Access Compliance Report

Public Rights-of-Way

Intersection ID: 47753	Main Street: ARBOR_CREEK_DR	Cross Street: REBECCA_RUN_DR	Location: S
ADA ID: 3BDBC79FEE55	Ramp Type: PerpDiag	Initial Pass/Fail: Fail	Overall Compliance: No
		Severity Score: 37.5

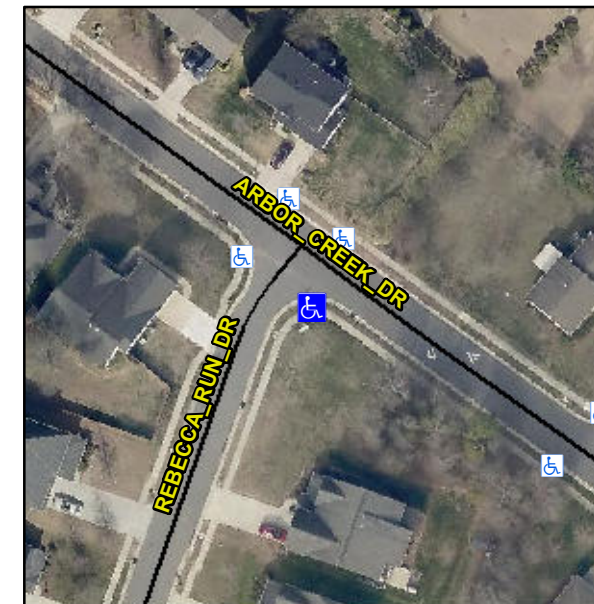
Not Found, R304.2.2, R304.5.3

Compliance	Description	Data	Compliance	Description	Data
N/A	Ramp Length (in)	47.0	No	Ramp Slope (%)	9.2
Yes	Ramp Width (in)	48.0	No	Ramp XSlope (%)	9.4
N/A	Flare Type LT	N/A	N/A	Flare Type RT	N/A
N/A	Flare Slope LT (%)	N/A	N/A	Flare Slope RT (%)	N/A
N/A	Flare Traversable LT?	N/A	N/A	Flare Traversable RT?	N/A
N/A	Landing Length (in)	N/A	N/A	DWS Provided?	N/A
N/A	Landing Width (in)	N/A	N/A	DWS Contrast?	N/A
N/A	Landing Slope (%)	N/A	N/A	DWS Length (in)	N/A
N/A	Landing X Slope (%)	N/A	N/A	DWS Full Width?	N/A
N/A	Landing Curb? (Y/N)	N/A	N/A	DWS Offset (in)	N/A
N/A	Shared Landing?	N/A			
N/A	Gutter Ponding?	N/A	N/A	Gutter Slope (%)	N/A
N/A	Gutter Lip Ht (in)	N/A	N/A	Gutter X Slope (%)	N/A
N/A	Painted X Walk1?	No	N/A	Painted X Walk2?	No
	X Walk 1 Direction	To NE		X Walk 2 Direction	To NW
N/A	X Walk 1 Width (in)	N/A	N/A	X Walk 2 Width (in)	N/A
	X Walk 1 Slope (%)	1.0		X Walk 2 Slope (%)	0.6
	X Walk 1 X Slope (%)	1.4		X Walk 2 X Slope (%)	7.1

Remove & Replace Curb Ramp With Two New Directional Ramps or Equivalent.
